# Access Compliance Report

## Public Rights-of-Way

### (Curb Ramps)

Intersection ID: 44243	Main Street: KIEV_DR	Cross Street: VALERIE_DR	Location: NW
ADA ID: 9331749A8401	Ramp Type: PerpDiag	Initial Pass/Fail: Fail	Overall Compliance: No
Severity Score: 17.5			
Codes/Mitigation Info/Possible Solution		Field Measurements/Component Compliance

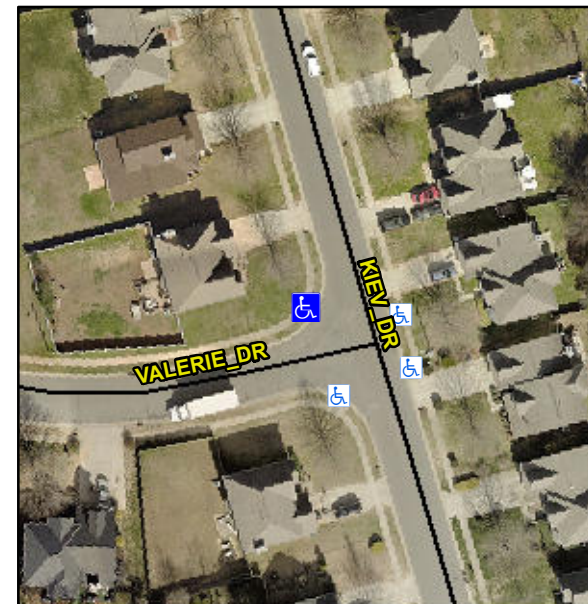
**Not Found, R304.5.1**

Compliance	Description	Data	Compliance	Description	Data
N/A	Ramp Length (in)	47.5	Yes	Ramp Slope (%)	6.6
No	Ramp Width (in)	35.0	Yes	Ramp XSlope (%)	1.2
N/A	Flare Type LT	N/A	N/A	Flare Type RT	N/A
N/A	Flare Slope LT (%)	N/A	N/A	Flare Slope RT (%)	N/A
N/A	Flare Traversable LT?	N/A	N/A	Flare Traversable RT?	N/A
N/A	Landing Length (in)	N/A	N/A	DWS Provided?	N/A
N/A	Landing Width (in)	N/A	N/A	DWS Contrast?	N/A
N/A	Landing Slope (%)	N/A	N/A	DWS Length (in)	N/A
N/A	Landing X Slope (%)	N/A	N/A	DWS Full Width?	N/A
N/A	Landing Curb? (Y/N)	N/A	N/A	DWS Offset (in)	N/A
N/A	Shared Landing?	N/A			
N/A	Gutter Ponding?	N/A	N/A	Gutter Slope (%)	N/A
N/A	Gutter Lip Ht (in)	N/A	N/A	Gutter X Slope (%)	N/A
N/A	Painted X Walk1?	No	N/A	Painted X Walk2?	No
	X Walk 1 Direction	To S		X Walk 2 Direction	To E
N/A	X Walk 1 Width (in)	N/A	N/A	X Walk 2 Width (in)	N/A
	X Walk 1 Slope (%)	1.1		X Walk 2 Slope (%)	1.6
	X Walk 1 X Slope (%)	0.8		X Walk 2 X Slope (%)	1.4

**Remove & Replace Curb Ramp With Two New Directional Ramps or Equivalent.**
